JOB NO.: **21065**
 PRINT DATE:
 PLOT DATE: 6.9.2022
 DRAWN BY:
 CHECKED BY: MH
 SET ISSUED:
 REVIEW SET: 01/04/2022
 CONDITIONS OF APPROVAL: 01/31/2022
 ADDENDUM NO. 3
 FENCING REV: 06/09/2022

SHEET NAME:
ENLARGED SITE PLAN
 SHEET NO.:
A101
 FILE NAME: 21065-A100

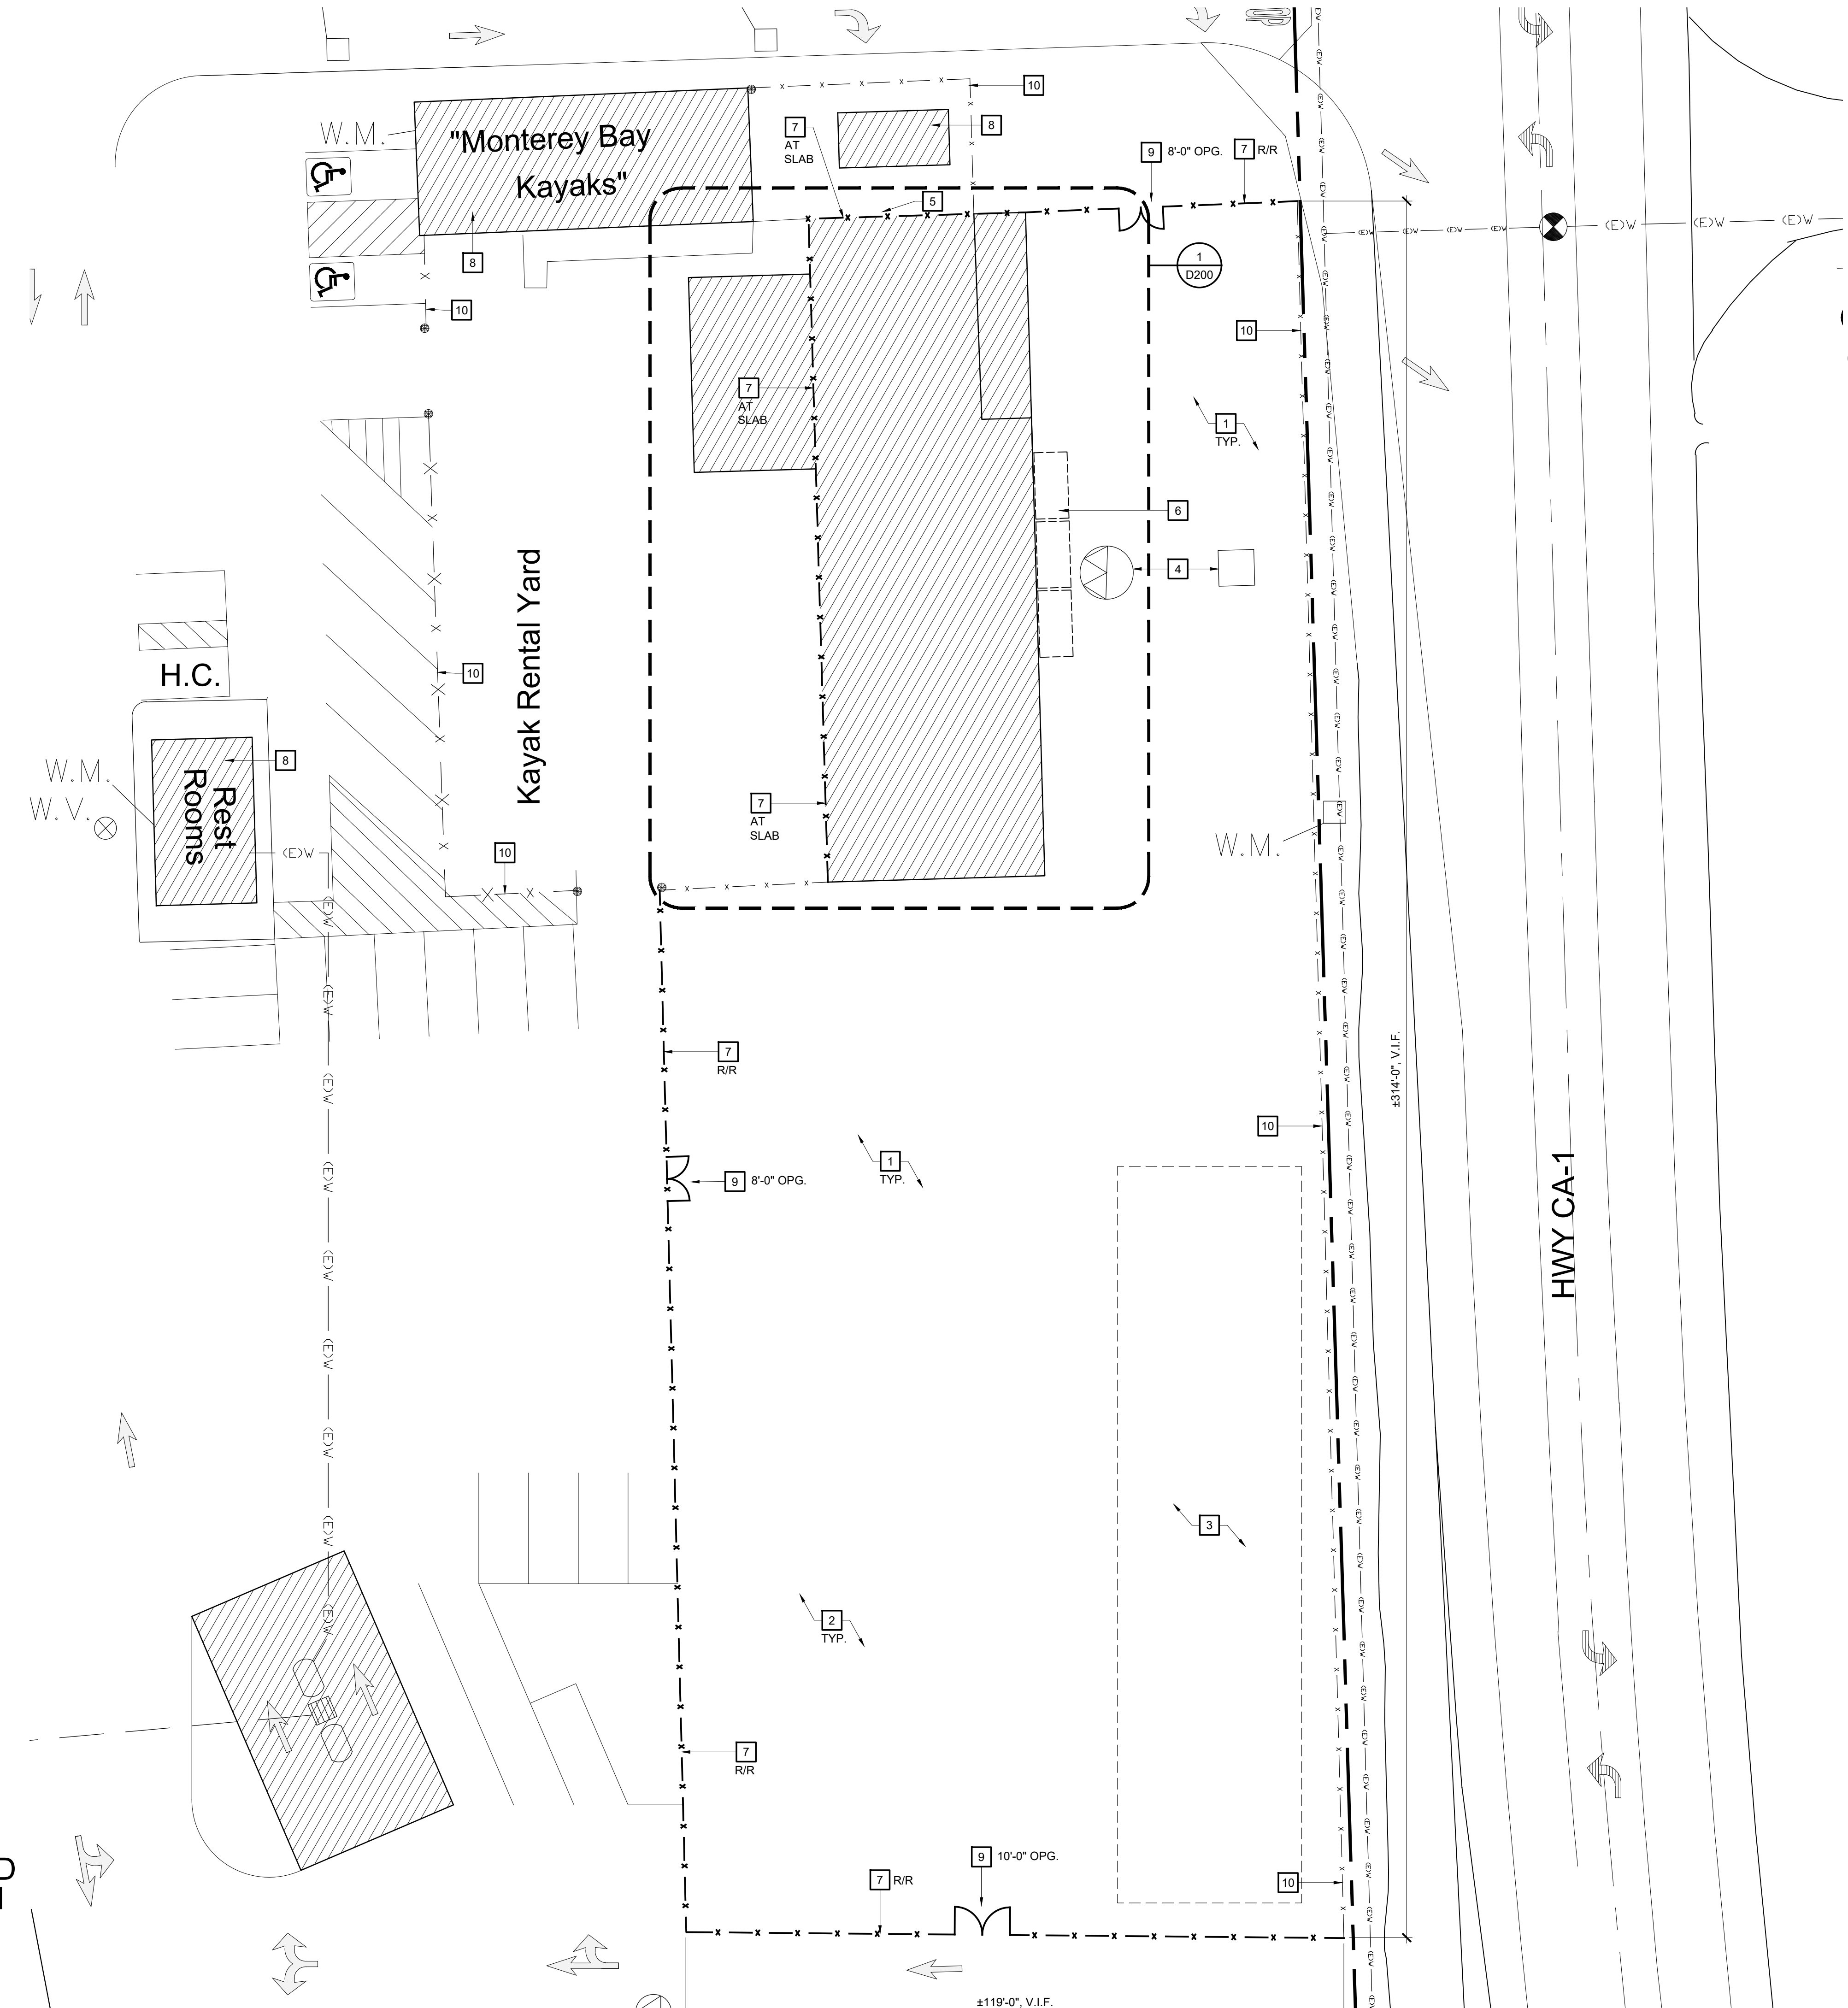
- 7 REMOVE AND REPLACE EXISTING CHAIN LINK FENCING AND EXTEND ALONG PERIMETER OF BUILDING SLAB AT DEMOLISHED MAIN BUILDING AS INDICATED. REPLACE FENCING AND GATES TO MATCH EXISTING FENCING TO REMAIN FACING HIGHWAY ONE AND NORTH DRIVEWAY SEEN IN PHOTO BELOW AND AS FOLLOWS:

- 1.90" O.D. GALV. SCHEDULE 40 LINE AND GATE POSTS @ 10 FOOT O.C. MAX SET IN MIN. 8" DIAMETER X 30" DEEP CONCRETE FOOTINGS.
 - GALV. LINE POST CAPS
 - GALVANIZED FENCE FABRIC

- GALV. CONTINUOUS TENSION WIRE AT TOP AND BOTTOM
 - BROWN VINYL PRIVACY SLATS
- 8 EXISTING BUILDING TO REMAIN.
- 9 REMOVE AND REPLACE EXISTING CHAIN LINK FENCE GATE TO MATCH EXISTING AND AS FOLLOWS:

- 1.66" O.D. WELDED FENCE FRAMES FOR PAIR GATE OPENING SIZE AS INDICATED WITH PADLOCKABLE FORK LATCHES AND CENTER CAME BOLTS
 - GALVANIZED FENCE FABRIC

- BROWN VINYL PRIVACY SLATS
- 10 EXISTING CHAIN LINK FENCE TO REMAIN INCLUDING THE FENCING FACING HIGHWAY ONE AS INDICATED.
